June 12, 2009

UN#09-280

Subject: UniStar Nuclear Energy, NRC Docket No. 52-016
Response to Request for Additional Information for the
Calvert Cliffs Nuclear Power Plant, Unit 3,
RAI No. 101, Groundwater

**Response for Request for Additional Information RAI No. 101,
Questions 02.04.12-1, -3, -5, -6 and -12, Groundwater,
Calvert Cliffs Nuclear Power Plant Unit 3**

Figure 2.4-64 - CCNPP Site Area Topography and Drainage

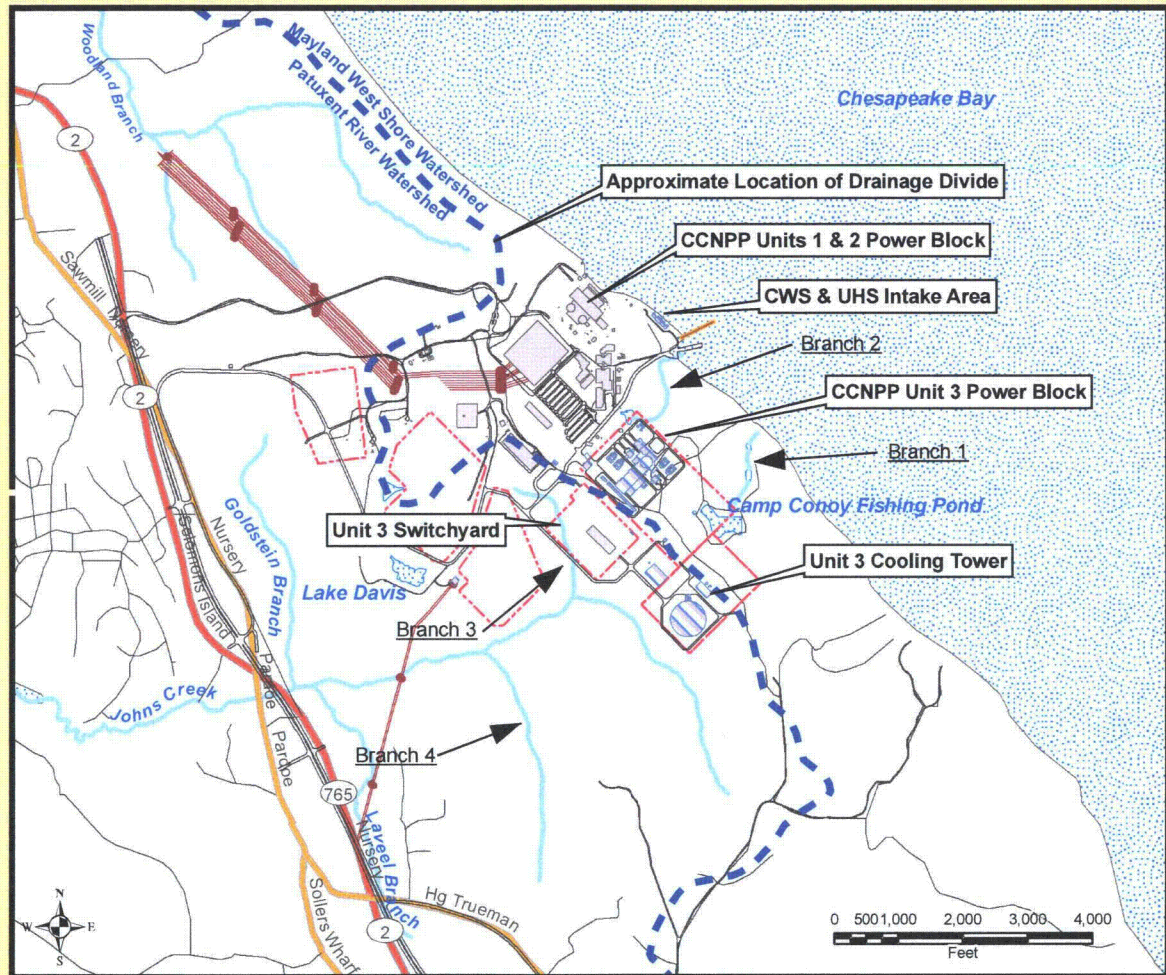
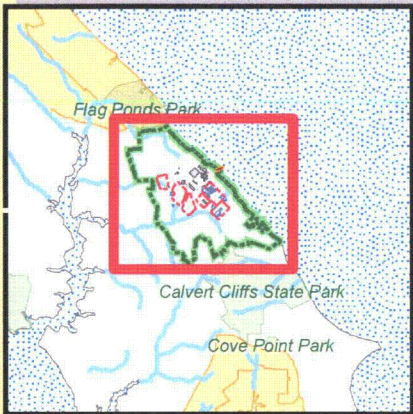
Legends of some FSAR figures in the electronic version are unreadable at any magnification (e.g., 2.4-68 and 2.4-70). Figures in Calculation No. 25237-103-KOC-HMMG-00001, Groundwater Flow Model of Surficial Aquifer, provided to Staff via the reading room, are in black and white and are less informative than they would have been if they had been in color and they are unreadable in some cases. Provide legible, color copies of all figures in FSAR section 2.4 and in Calculation No. 25237-103-KOC-HMMG-00001.

FSAR Figure Nos. 2.4-64, 2.4-65, 2.4-68, 2.4-70, 2.4-71, 2.4-72, 2.4-73, 2.4-75, 2.4-76, 2.4-77, 2.4-78, 2.4-80, 2.4-81, 2.4-82, 2.4-83, 2.4-85, 2.4-86, 2.4-99, 2.4-100, 2.4-101, 2.4-102, 2.4-103, 2.4-104 and 2.4-105 have been revised to enlarge their legends. Figures in Calculation No. 25237-103-KOC-HMMG-00001, Rev 0, Groundwater Flow Model of the Surficial Aquifer, were provided in color in the reading room at the office of Tetra Tech NUS in Richland, Washington by way of transmittal letter 25237-000-T8S-HY00-00002, dated October 10, 2008. Figures in color for Rev 1 of Calculation No. 25237-103-KOC-HMMG-00001 were provided in the reading room at the office of Tetra Tech NUS in Richland, Washington by way of transmittal letter 25237-000-T8S-HY00-00003, dated December 23, 2008.

Figures 2.4-64, 2.4-65, 2.4-68, 2.4-70, 2.4-71, 2.4-72, 2.4-73, 2.4-75, 2.4-76, 2.4-77, 2.4-78, 2.4-80, 2.4-81, 2.4-82, 2.4-83, 2.4-85, 2.4-86, 2.4-99, 2.4-100, 2.4-101, 2.4-102, 2.4-103, 2.4-104 and 2.4-105 in FSAR Section 2.4 will be updated as follows in a future COLA revision.

Figure A - Stratigraphy, Screen Interval and Groundwater Levels in Observation Well OW-744 Relative to Nearby Wells in the Shallow Aquifer

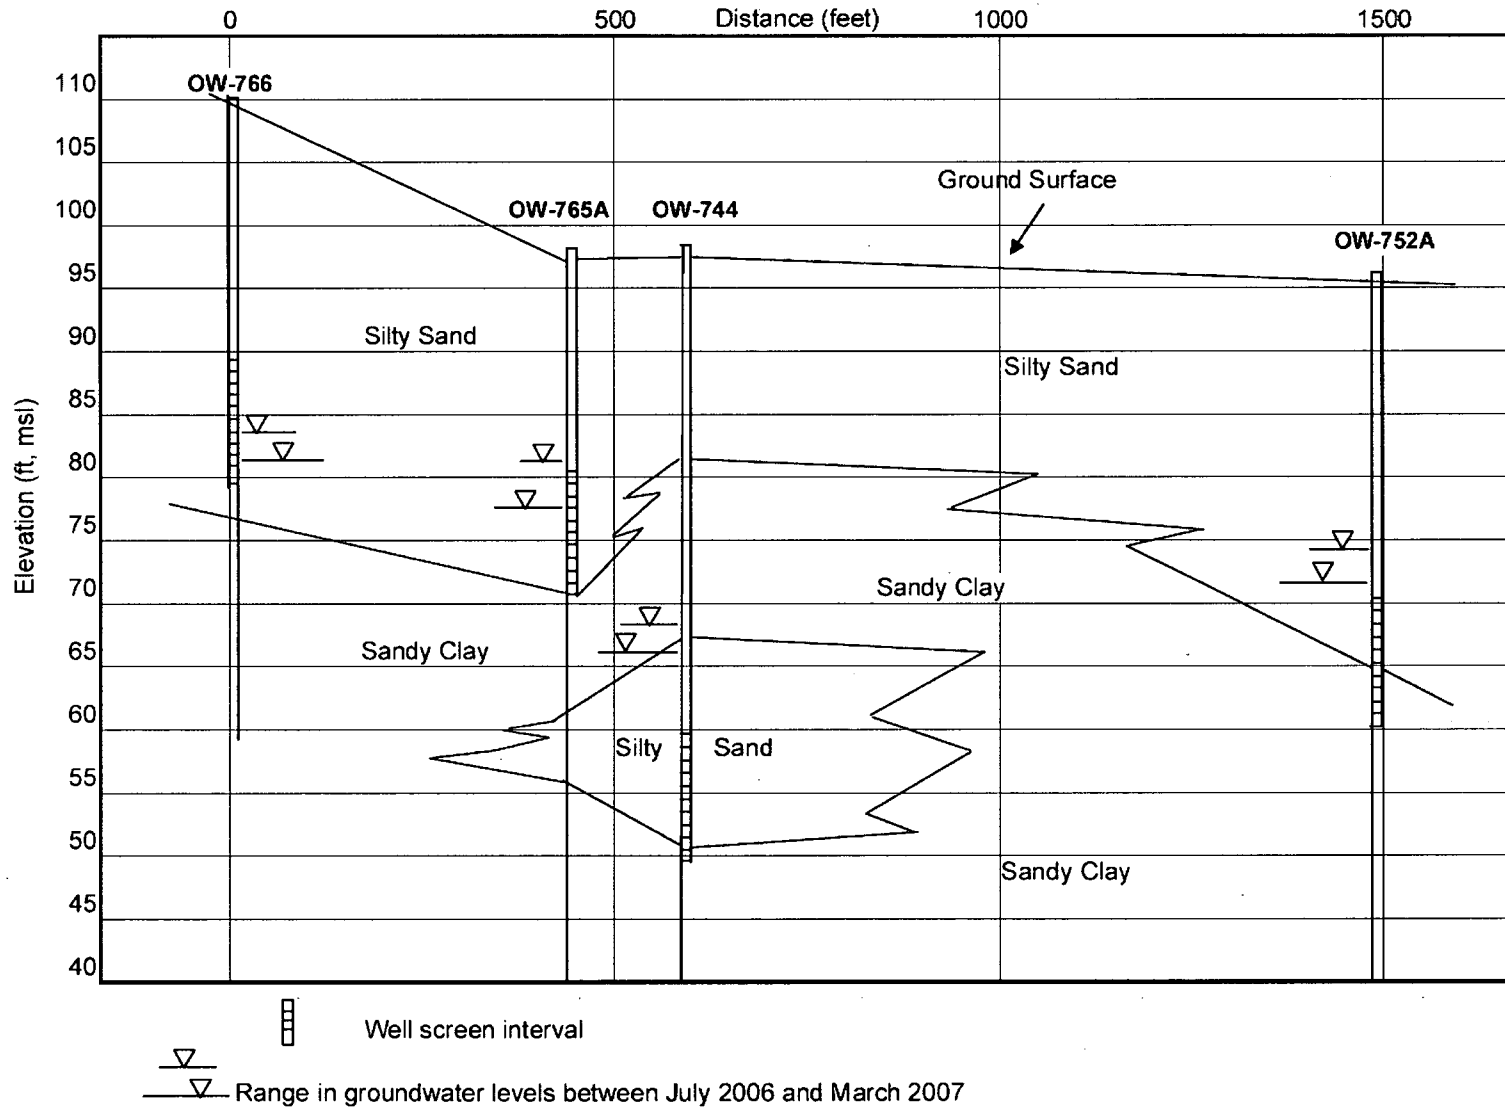
Provide a description of the water budget at the site. This description should include estimates of recharge to the surficial aquifer, recharge to the Chesapeake units from the surficial aquifer, and recharge to the Piney Point-Nanjemoy aquifer from the Chesapeake. Regional information can be used in developing these estimated recharge values. Provide a three-dimensional conceptual description of groundwater flow within and between these units (Surficial aquifer, Chesapeake units and Piney-Point Nanjemoy aquifer), provide an interpretation of the available groundwater head data (particularly from well OW-744) within the context of the three-dimensional conceptual description, and discuss the potential for a groundwater pathway from the CCNPP facility to the Piney-Point Nanjemoy aquifer.

Observation well OW-744 is screened in a discontinuous silty sand unit vertically isolated from the Upper and Lower Chesapeake Units. Therefore, water-level elevation data from this well is not used in the hydrogeologic evaluations of these units. An evaluation of the geologic logs for the soil borings in which observation wells were constructed reveals that the stratigraphy encountered in well OW-744 differs from that in the nearby wells. Figure 2.4-68 shows that the eight Surficial aquifer wells OW-323, OW-423, OW-428, OW-436, OW-752A, OW-756, OW-765A and OW-766 are located in the vicinity of OW-744. The screen for each of these eight nearby wells is completed in a layer of silty sand that extends generally from the ground surface to a clay layer whose top surface is at an elevation that ranges from 77 to 60 ft msl. This clay layer is an aquitard whose bottom elevation ranges from about 47 to 31 ft msl.

At well OW-744 a relatively thin layer of silty sand extends from the ground surface to an elevation of 82 ft msl. Sandy clay underlies this layer, to an elevation of 67 ft msl. Below the sandy clay is a lens of silty sand from 67 to 51 ft msl. More sandy clay exists below this interval. The screen for OW-744 is in the interval from 59.5 to 49.5 ft msl, whereas the screens for the closest wells in the Surficial aquifer (each 10 ft long) are completed higher in the section, within the interval from 88.9 to 60.3 ft msl (Figure A). The nearby wells in the Upper Chesapeake Unit have screens completed below the sandy clay aquitard (Figure B) and the four closest to OW-744 (OW-328, OW-336, OW-752B and OW-765B) are within the interval from 37.1 to 0.8 ft msl.

OW-744 is screened in a discontinuous silty sand lens not hydraulically connected with the shallower silty sand in which the wells in the Surficial aquifer are screened or the deeper silty sand in which the wells in the Upper Chesapeake Unit are screened. As a result, the water level in OW-744 is consistently lower than the water levels in the nearby Surficial aquifer wells and higher than the water levels in the nearby Upper Chesapeake Unit wells. FSAR Table 2.4-35 shows that during the period July 2006 through June 2007, the water level in OW-744 ranged from 66.29 to 68.48 ft msl, whereas the water levels in the eight nearby Surficial aquifer wells ranged from 71.64 to 85.74 ft msl and the water levels in the four nearby Upper Chesapeake Unit wells ranged from 36.45 to 40.31 ft msl. These relationships are illustrated on the attached cross-sections.

Figure 2.4-69 Groundwater Elevations for the Surficial Aquifer,
July 2006 through June 2007

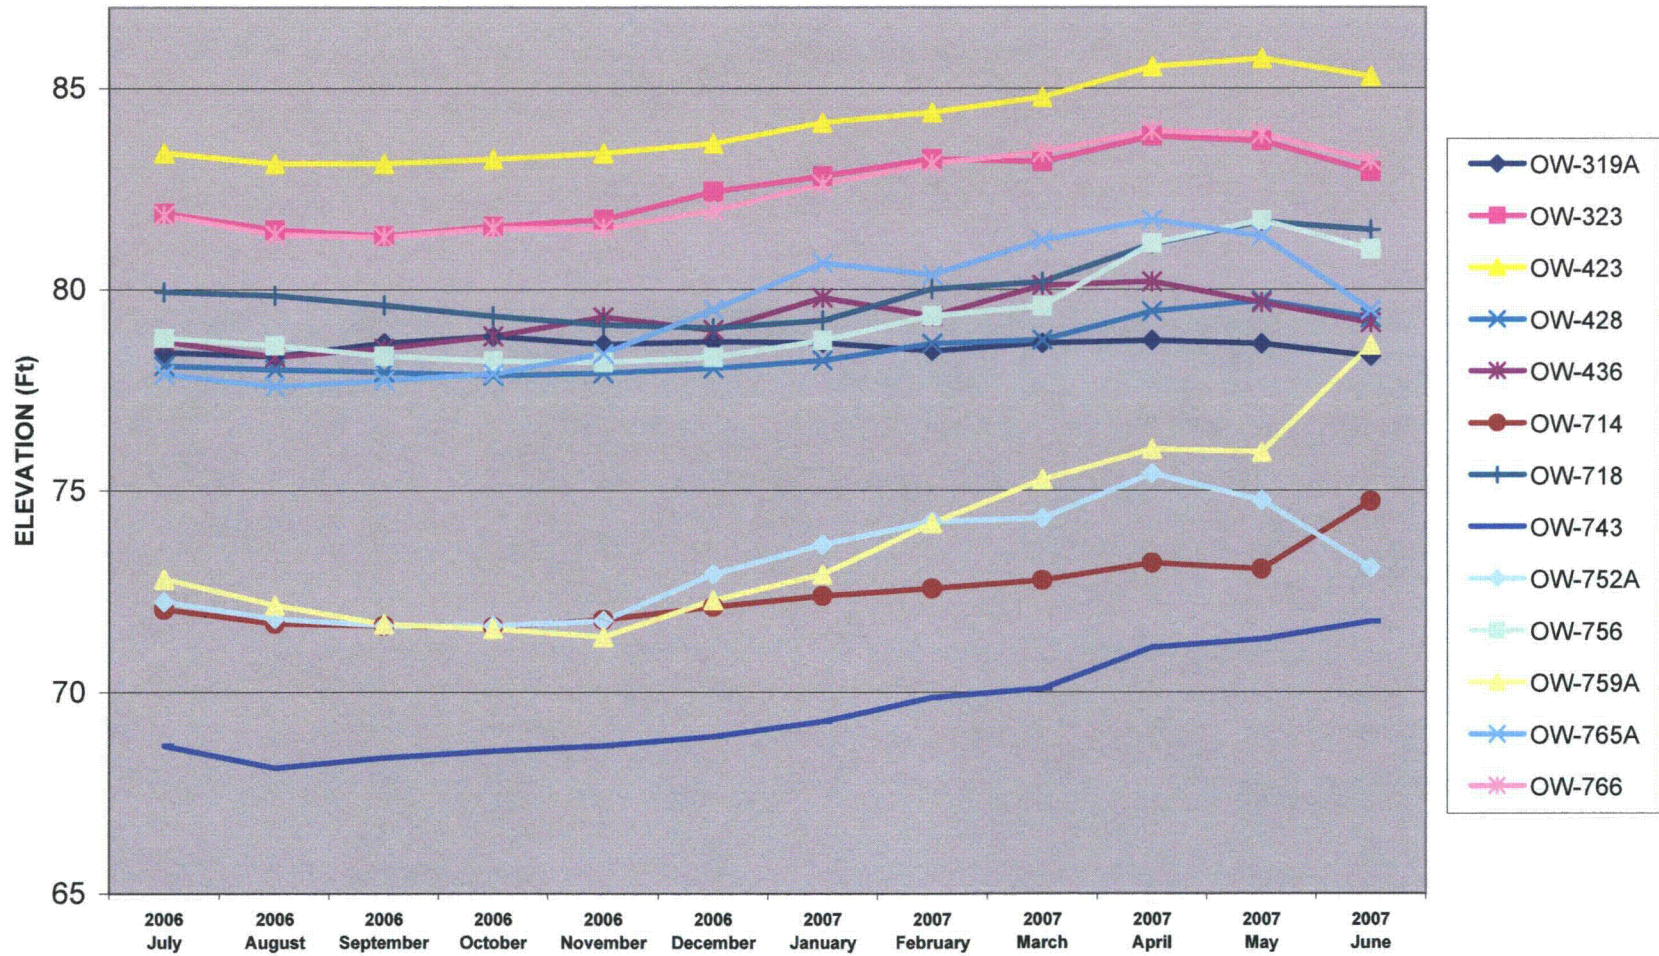
Groundwater heads and estimated hydraulic gradients were observed to be variable in time. Given the limited number of observations (one year of monthly head data) provide a discussion of the potential impact of temporal variability in head on the estimated groundwater velocities and travel times.
